REQUEST FOR INFORMATION (RFI)

Solicitation Description: Willows Memorial Park Accessibility and Beautification Project

RFI Number: 001

Staging Area

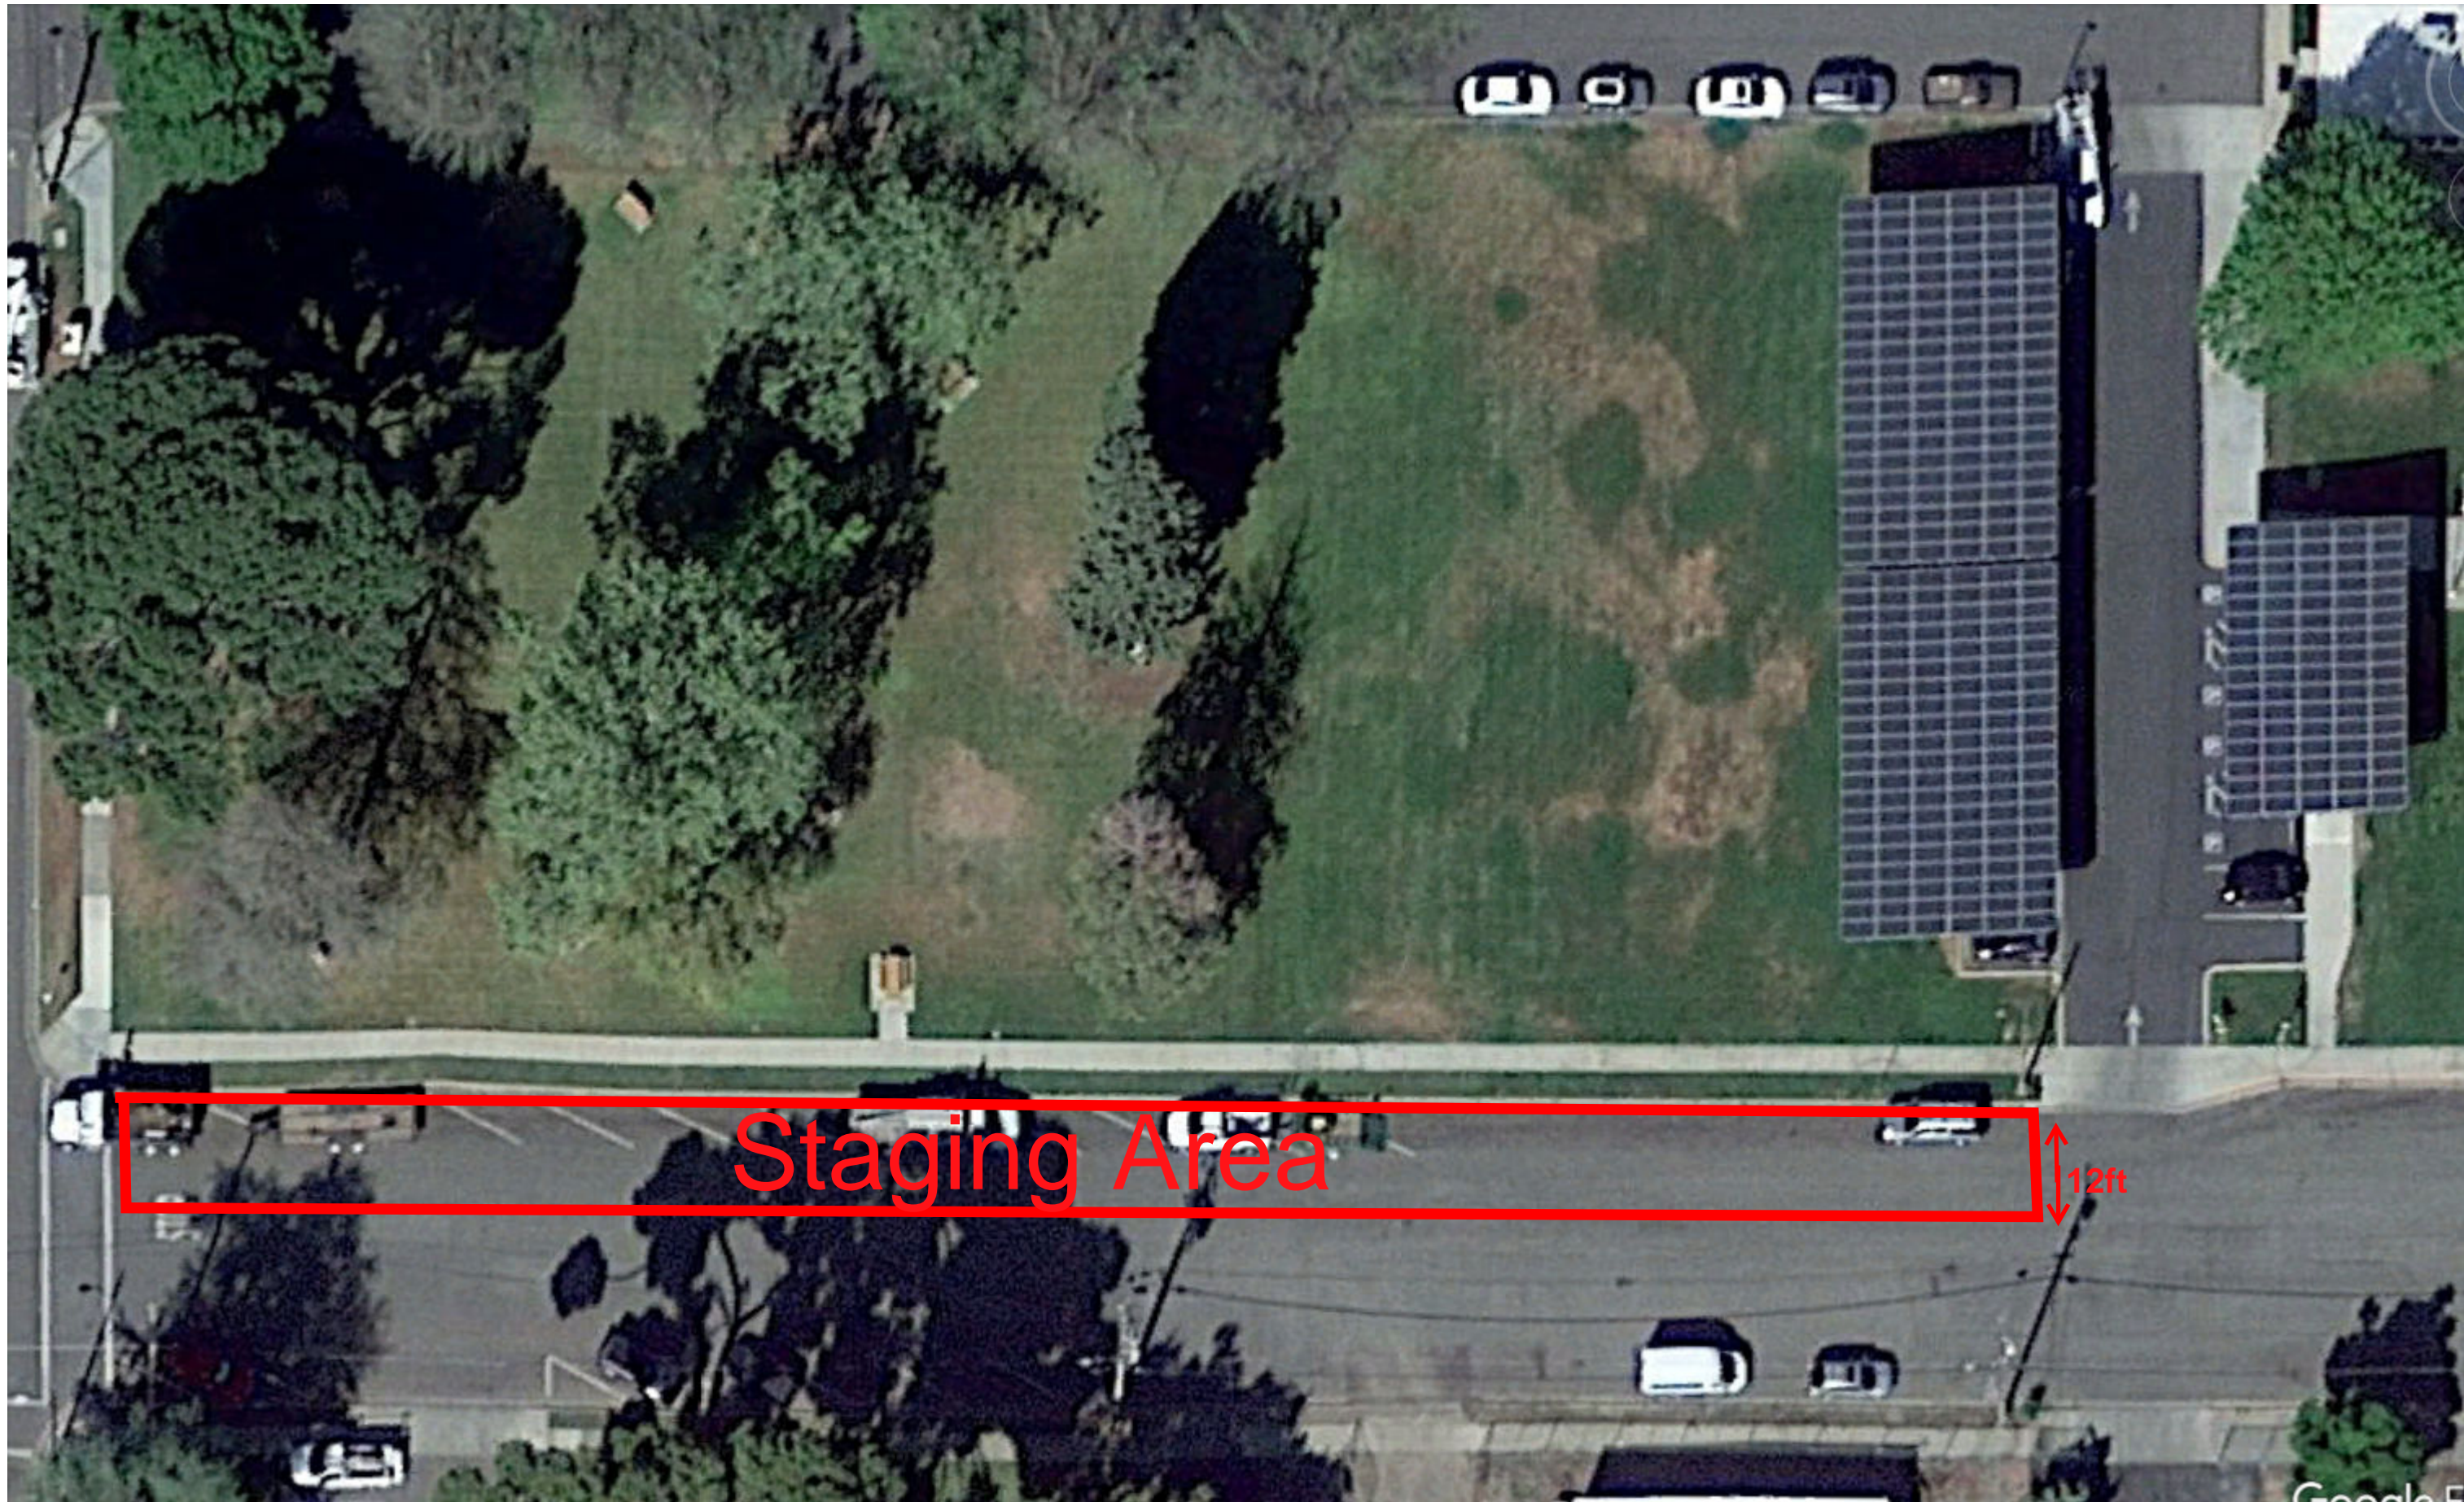
4. Response: Within the fenced area where the pump is located across the street to the east.
- 5. Question:** Is there a staging area?
5. Response: See Attachment 1 for proposed location. Contractor is responsible for all encroachment permits as required by the City of Willows.
